## STAFF REPORT

**TO:** City Council  
**FROM:** Ben Prchal, City Planner  
**ITEM:** Northport 3<sup>rd</sup> Addition Final Plat and Easement Vacation  
**REVIEWED BY:** Ken Roberts, Planning Director  
Planning Commission

The City Council is being asked to review a Final Plat and Easement Vacation request for the Northport 3<sup>rd</sup> Addition.

## FINAL CONSTRUCTION PLANS

CITY PROJECT NO. ---	LAKE ELMO, MINNESOTA	FILE NO. 72905-326
<b>SATHRE-BERGQUIST, INC.</b> 150 SOUTH BROADWAY WAYZATA, MN, 55391 (952) 476-6000		<b>FINAL GRADING PLAN</b> NORTHPORT 3RD ADDITION PULTE GROUP	12 22

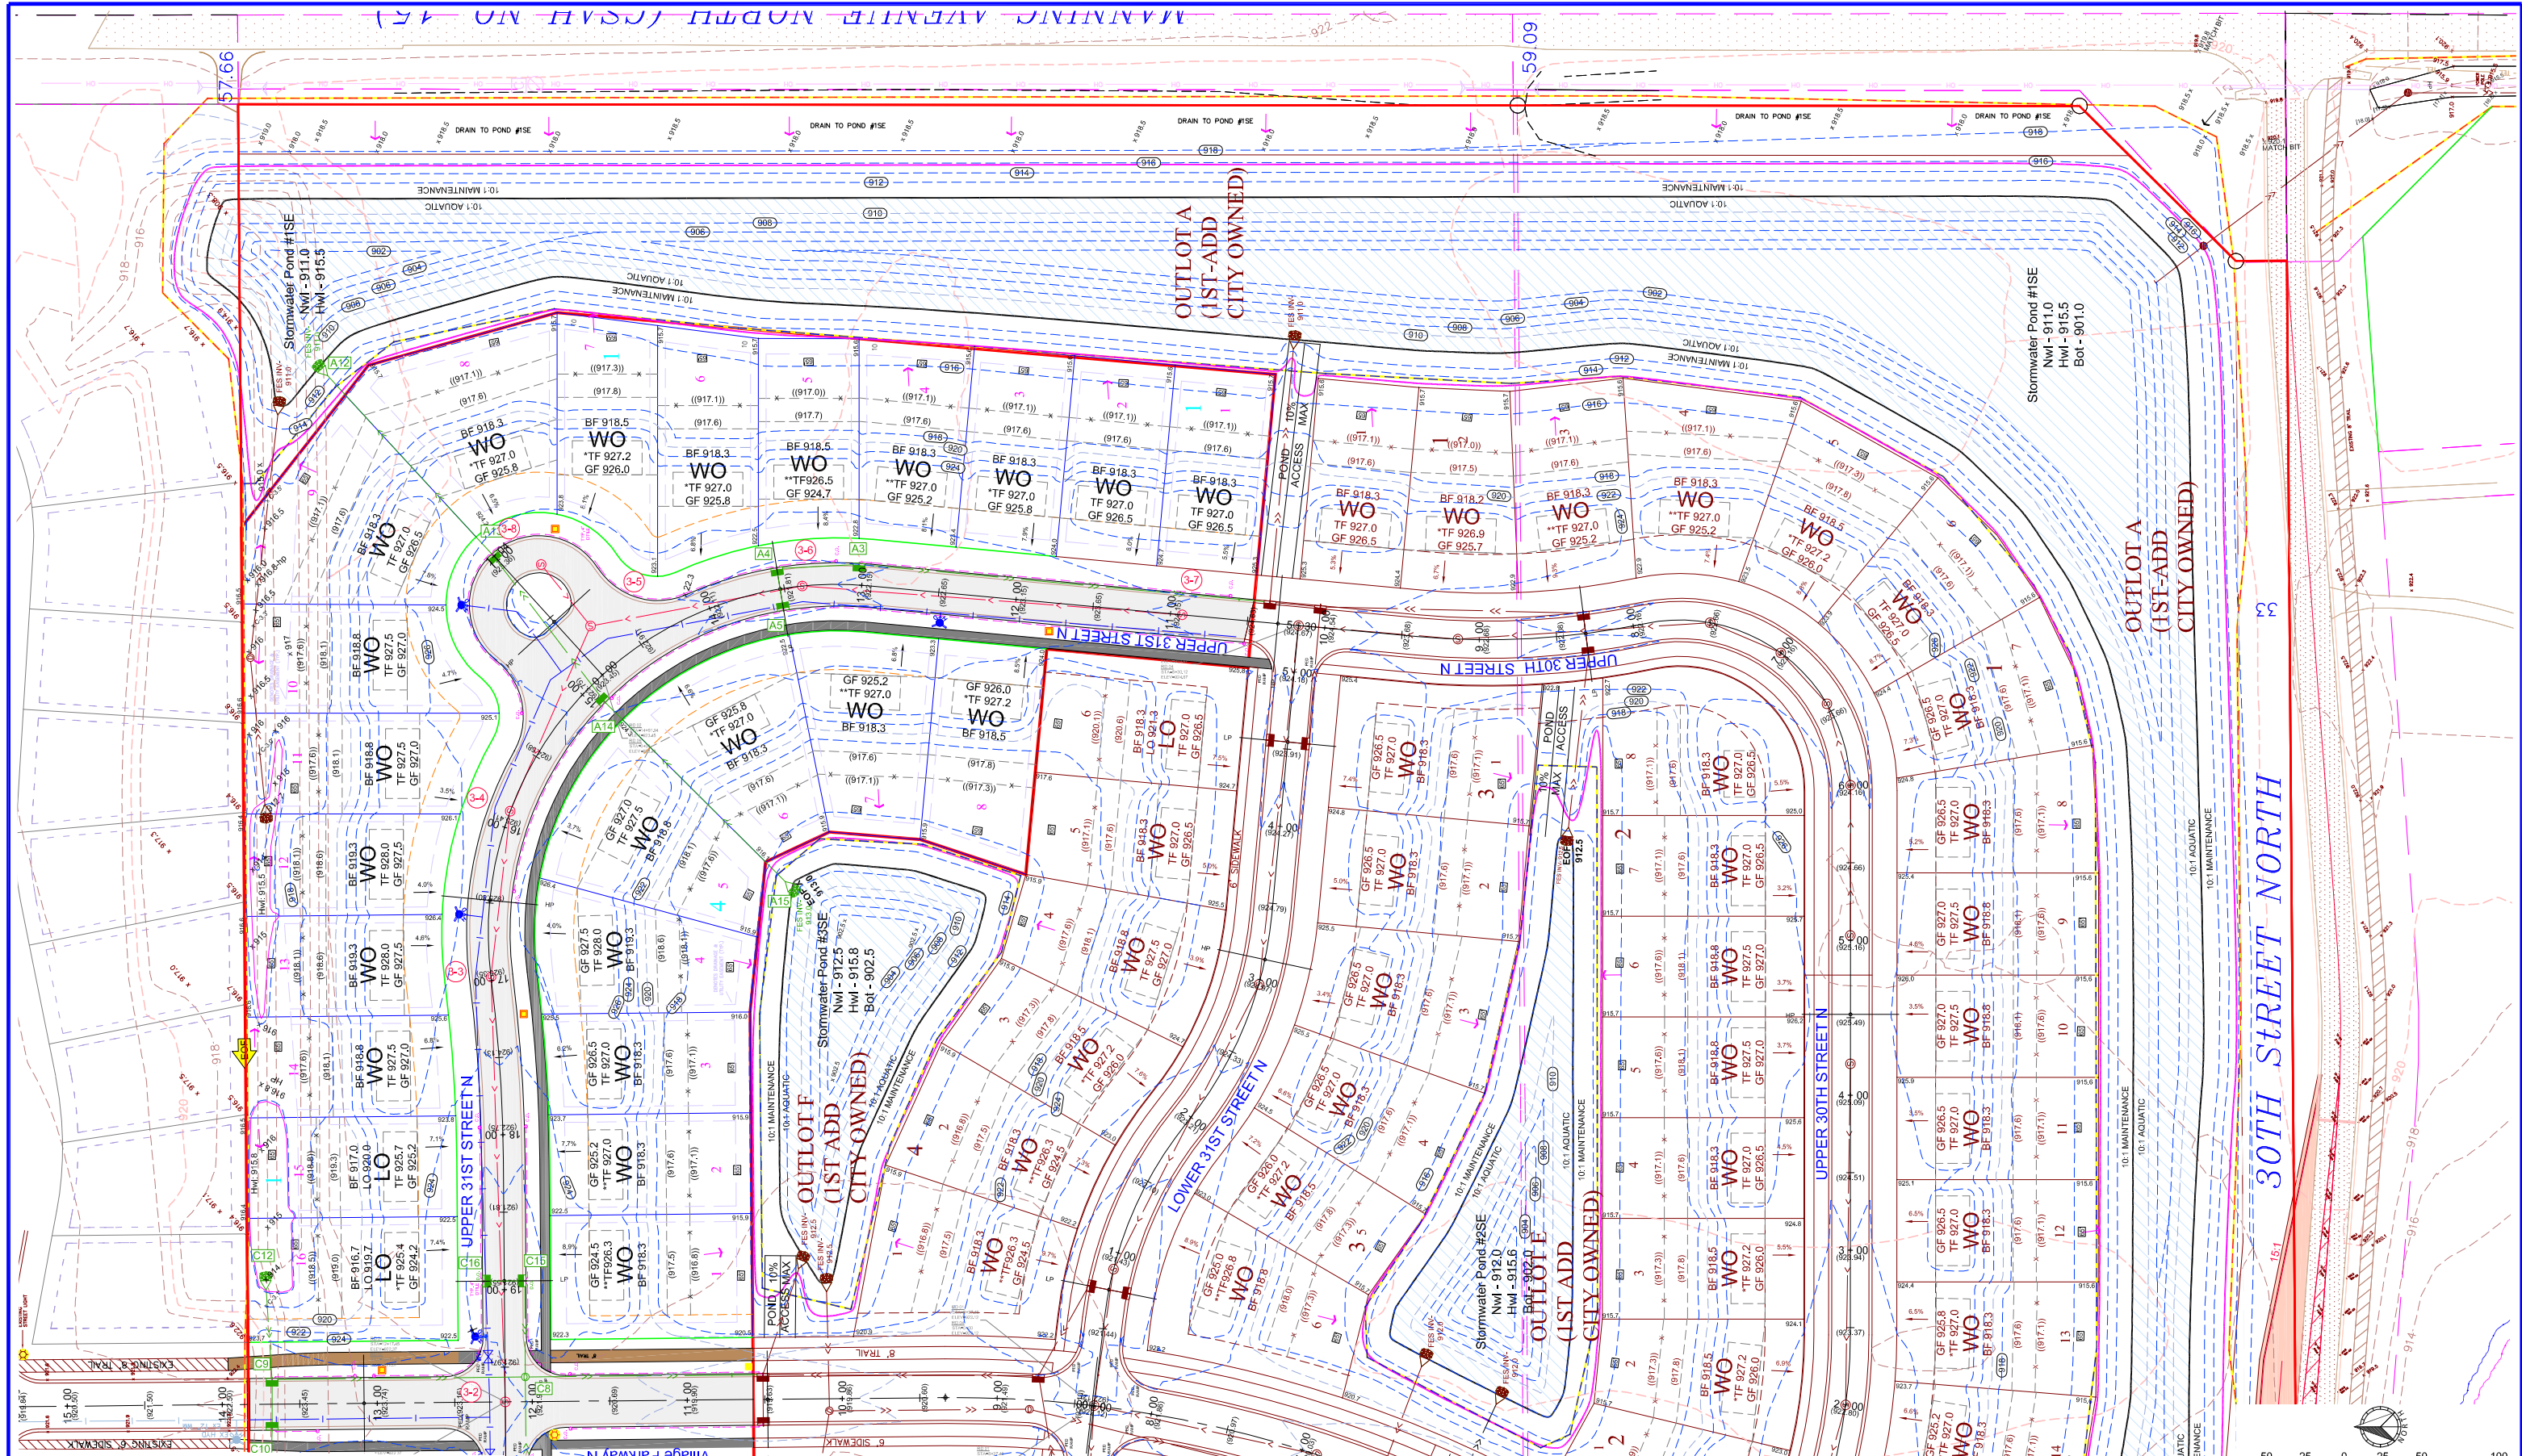
- Sheet 12. Final Grading. Revise plan sheet to number 13.
- Sheet 14. Add proposed missing rear lot corners for Lot 9, Block 1 (2x).
- Sheet 14. Lots 10-16, Block 1. Add spot elevations at all rear lot easement corners adjacent to the proposed 100-year HWL. As-built lot corners and easement corner elevations must be verified with as-built grading to maintain 100-year HWL within drainage and utility easements.

CITY PROJECT NO.		FILE NO.	72905-326
LAKE ELMO, MINNESOTA		15	
FINAL GRADING PLAN NORTHPORT 3RD ADDITION PULTE GROUP		22

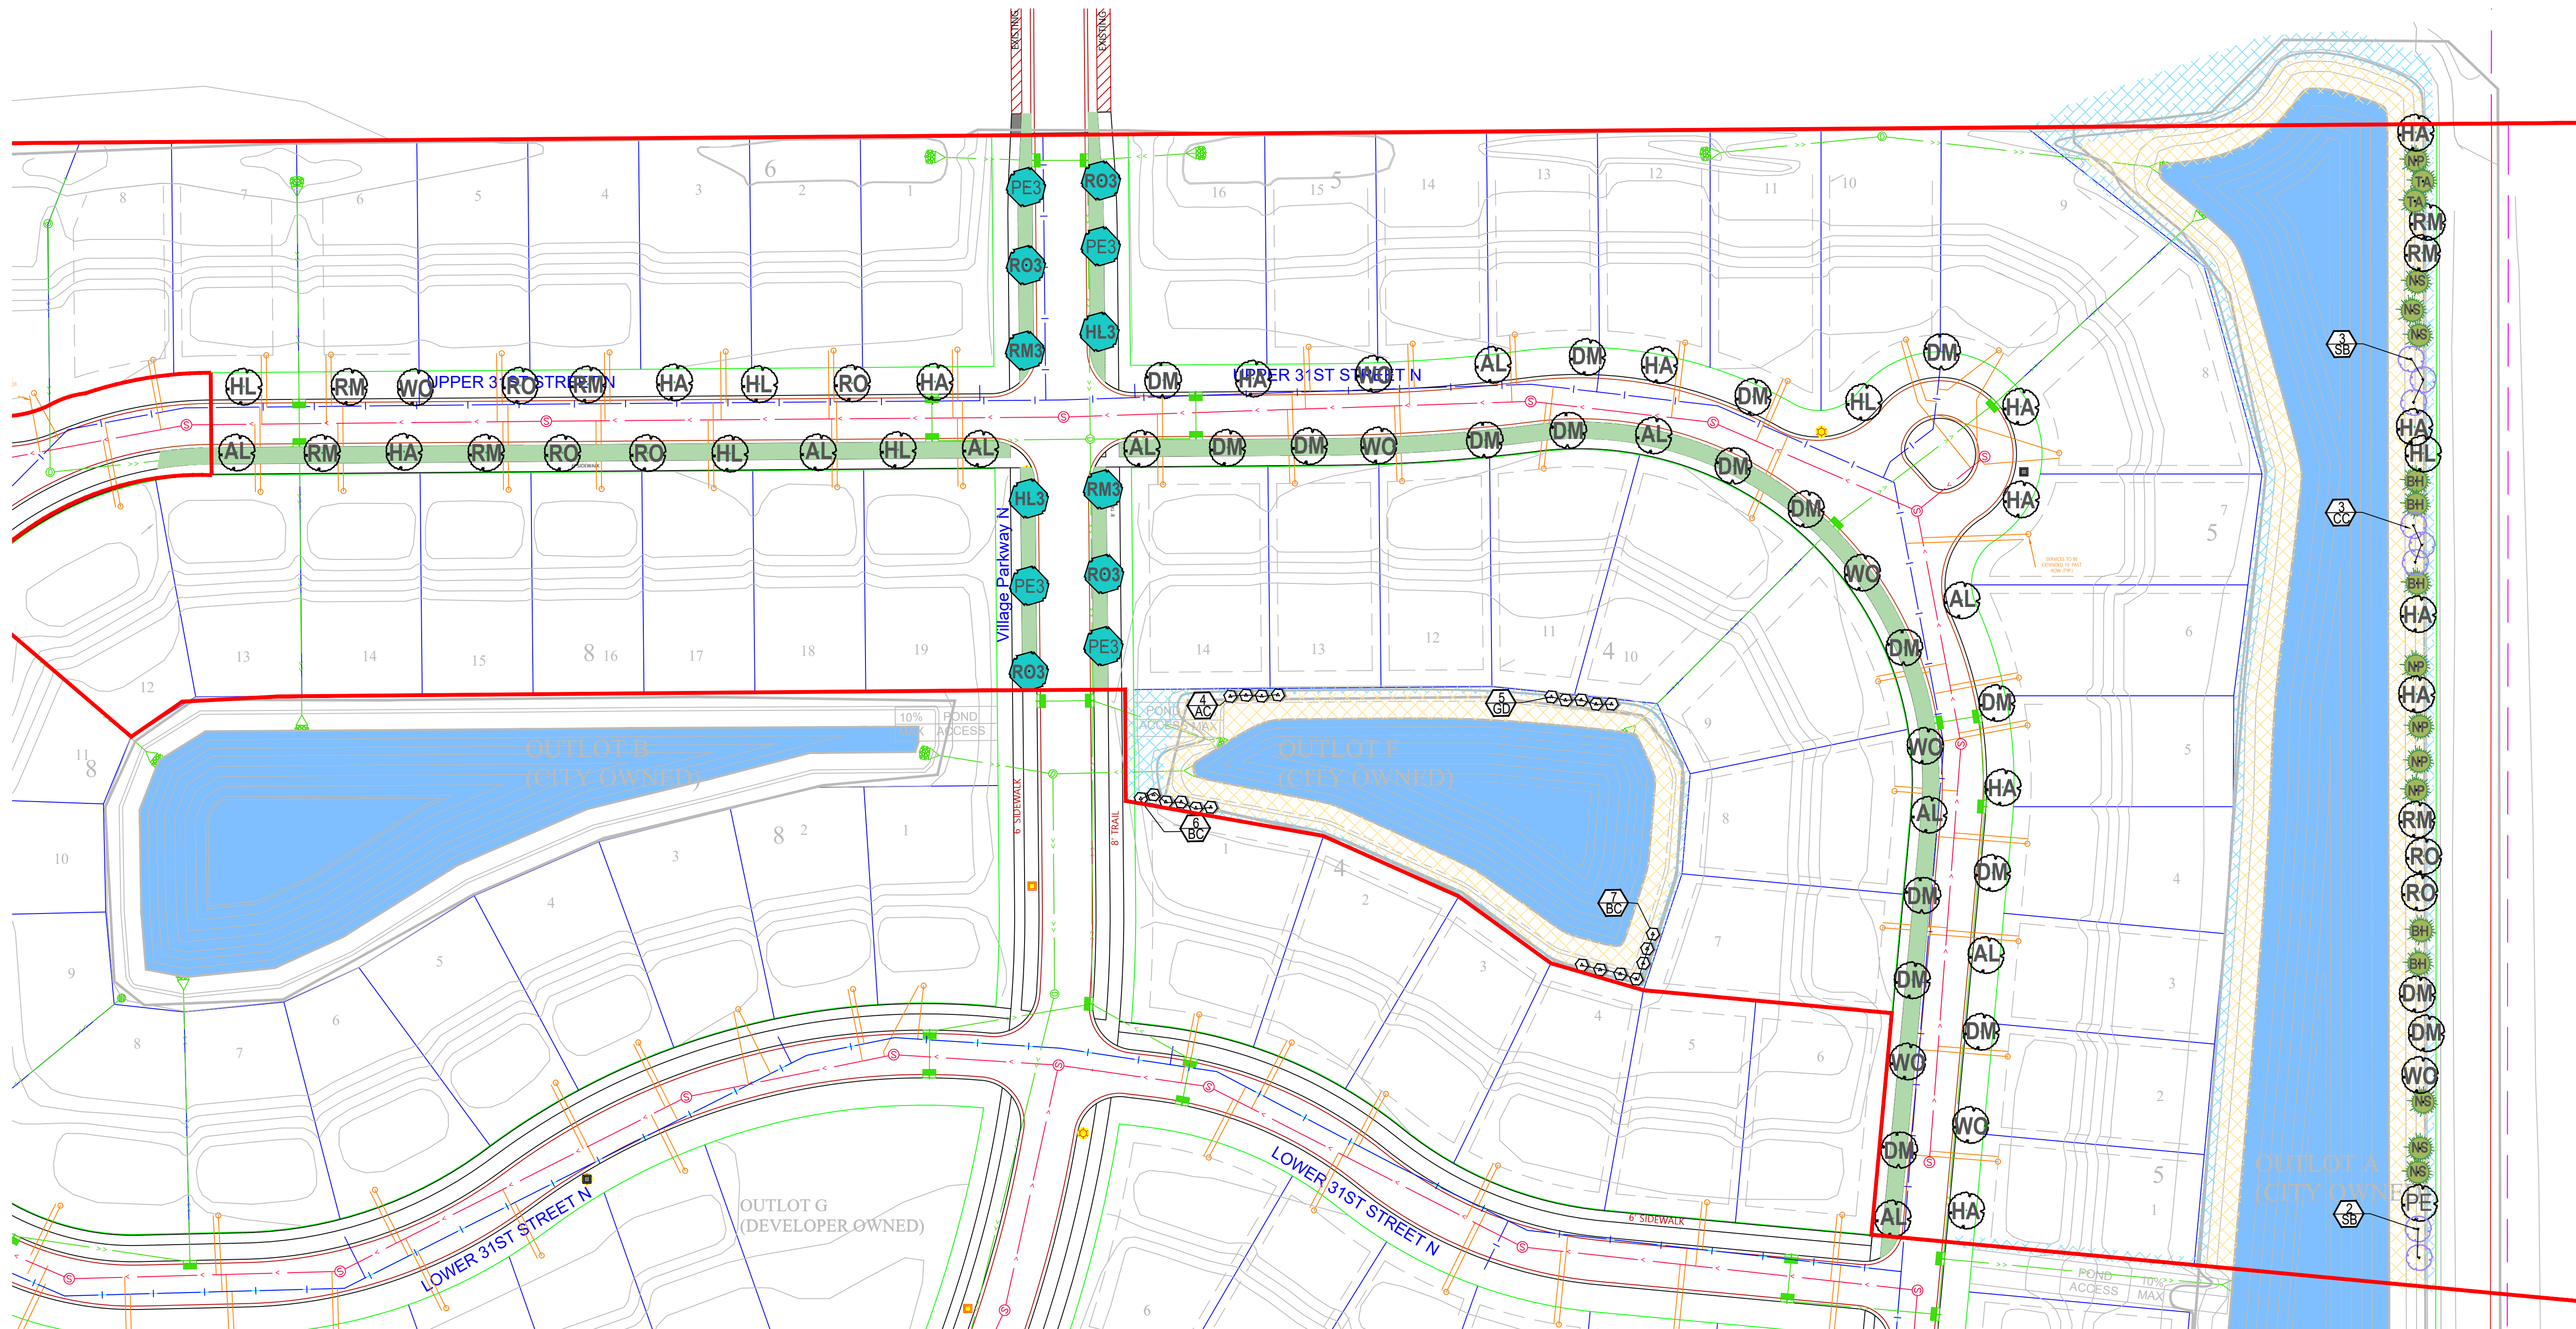
- Sheet 15. Correct legibility of rear lot corner between Lot 8-9, Block 2.
- Sheet 15. Lots 1-9, Block 2. Add spot elevations at all rear lot easement corners adjacent to the proposed 100-year HWL. As-built lot corners and easement corner elevations must be verified with as-built grading to maintain 100-year HWL within drainage and utility easements.

1 Tree and Shrub Plan  
 2 SCALE: 1" = 50'

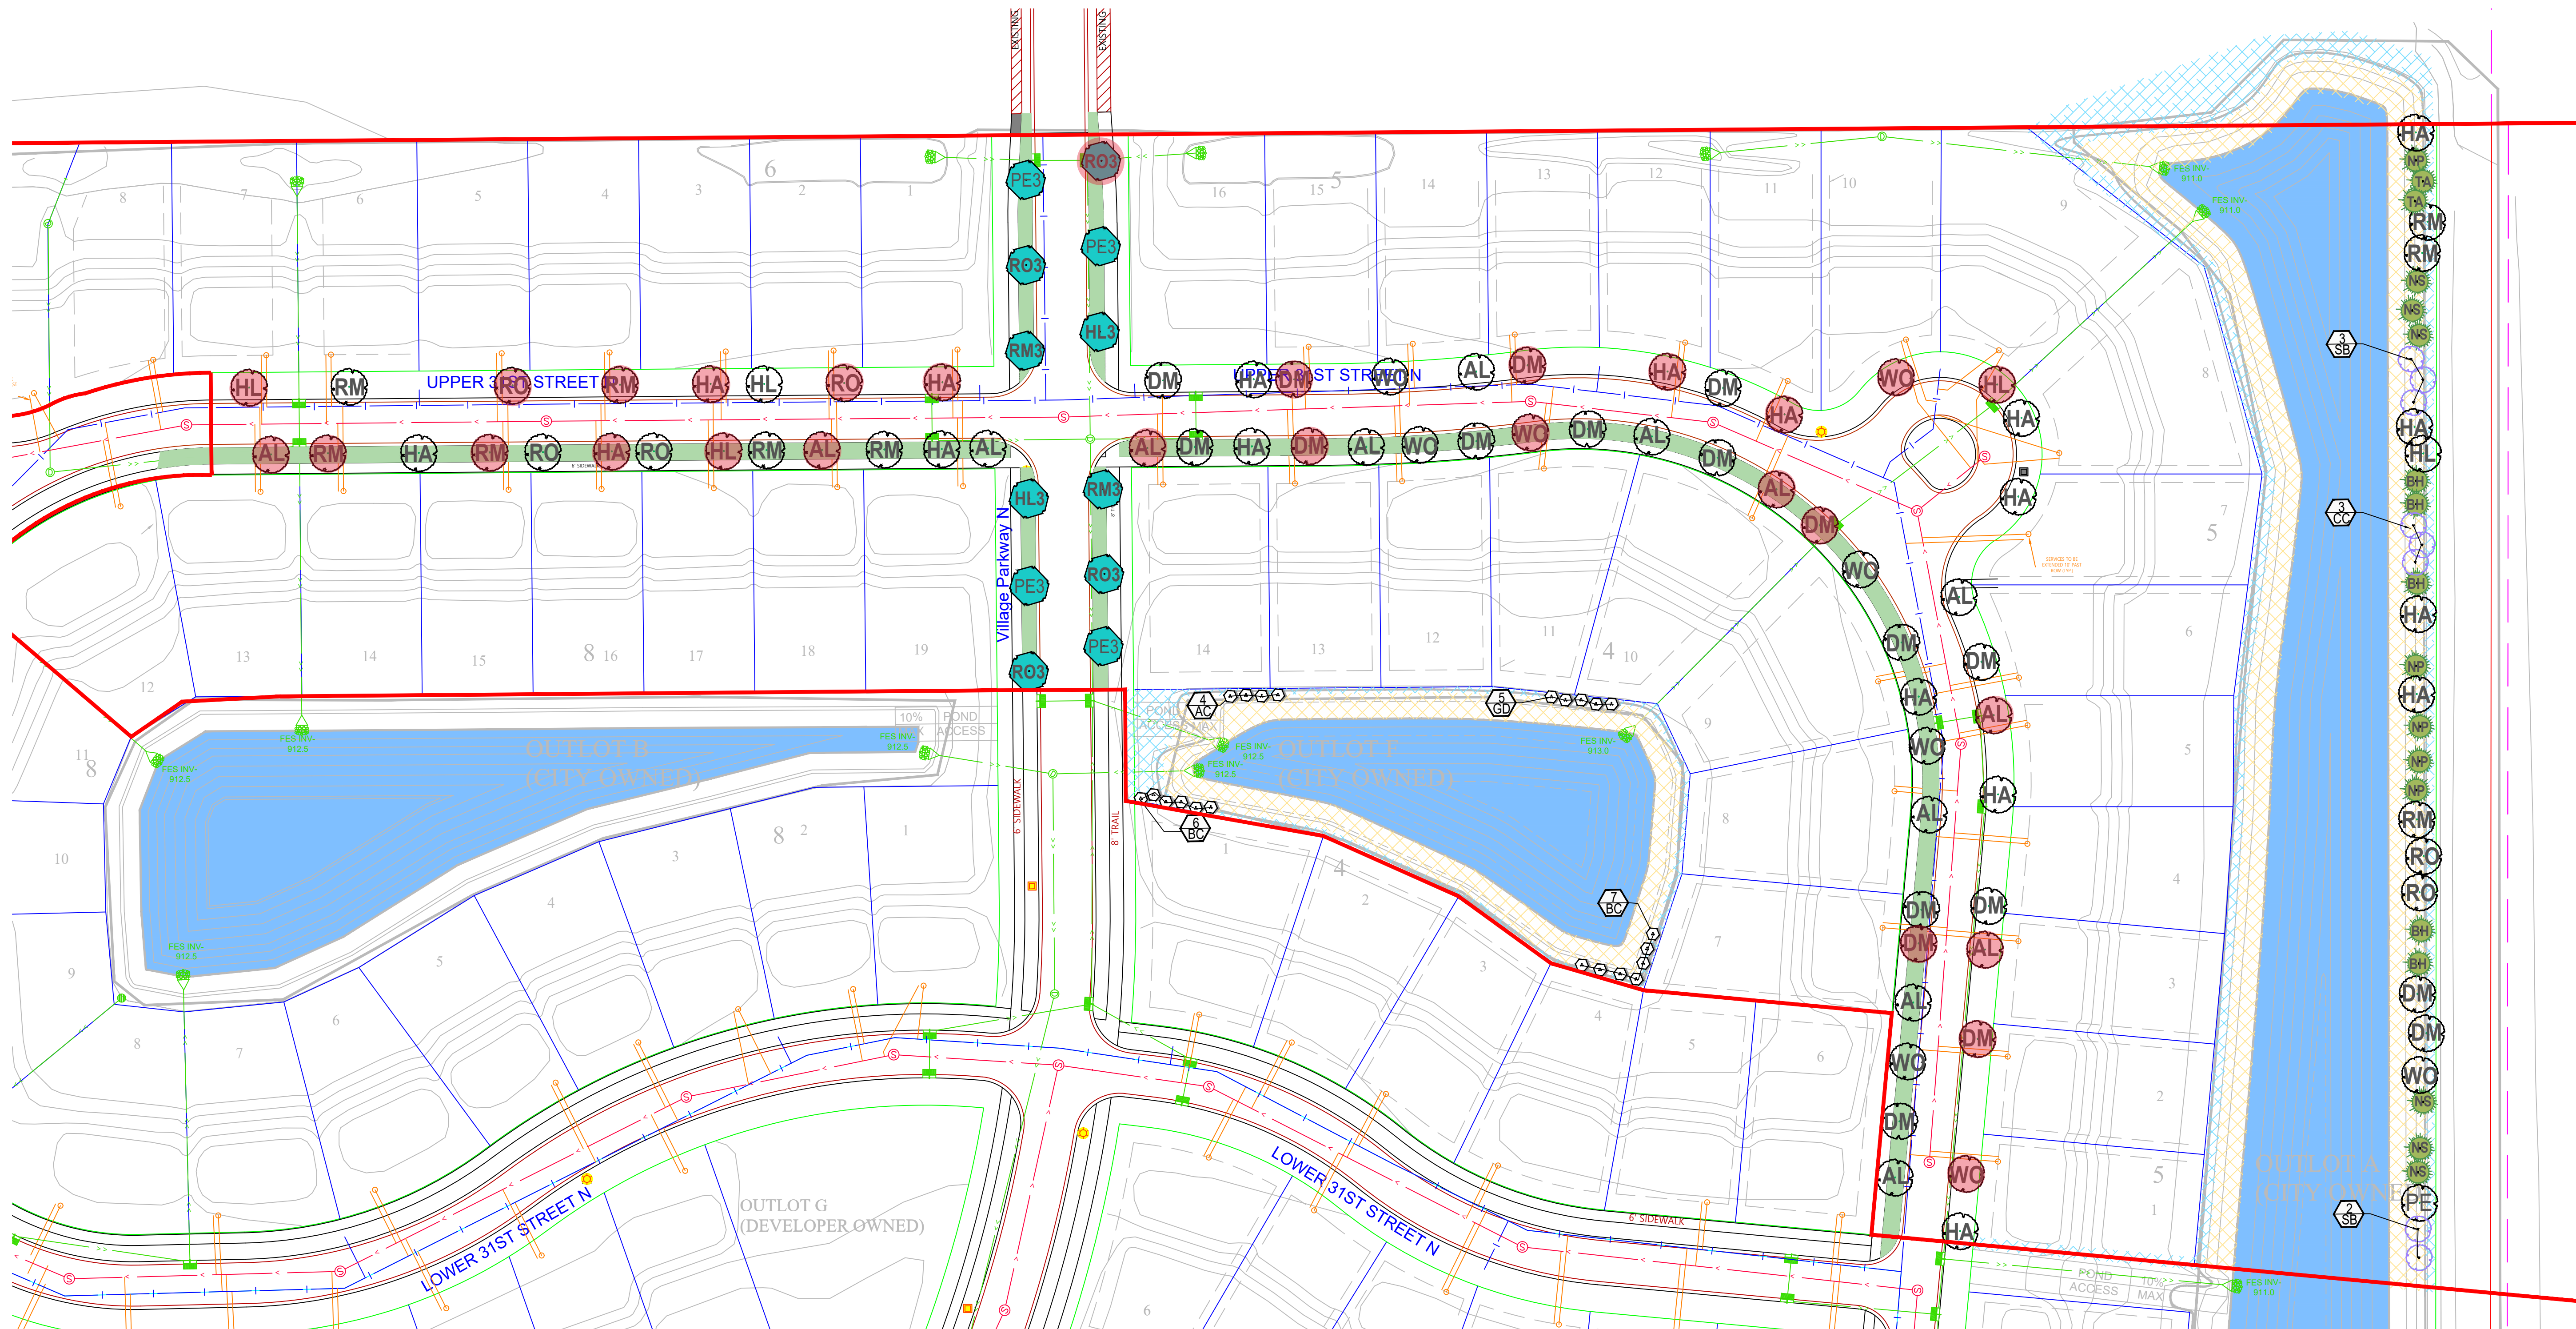
1. There are several proposed trees that conflict with utilities. See attached figure with conflicting trees highlighted in red. All trees must be 10' away from any utility line. In previous plan reviews the note,

was added to ensure there were no utility conflicts at the time of construction. Please add to Phase 3 sheets to ensure the same guidelines are followed. If there are still conflicts with utilities, some trees may be omitted since more trees are being provided than required. Trees may also be moved to the back of lots, but not planted in an outlot or easement area. Please review and move trees to fit these guidelines accordingly.

2. All trees must be 10' away from any driveway. The submitted landscape plan does not show proposed driveways, so any conflicts cannot be seen or corrected. A note similar to utility conflicts may be added to ensure there are no driveway conflicts. Trees may be moved to a different location or omitted since more trees are being provided than required. Trees may also be moved to the back of lots, but not planted in an outlot or easement area. Please revise the landscape plan to show proposed driveways and move trees to fit these guidelines accordingly.

3. Because this phase is along Village parkway, all boulevard trees must be 75' apart. This was the case in previous development phase reviews and will need to be continued for phase three. Please revise the 50' tree spacing along Village Parkway to 75' in accordance with code.

4. Because this phase is along Village parkway, all boulevard trees must be 6' off back of curb and 3' from edge of sidewalk or trail. It appears that these trees are currently spaced evenly between the sidewalk or trail and back of curb but will need to be adjusted to fit the dimensions provided on the City detail: Village Parkway Collector Typical Sections – South of Railroad Tracks. Please revise the tree spacing to be within the Village Collector guidelines.

1. Submit a revised landscape plan.
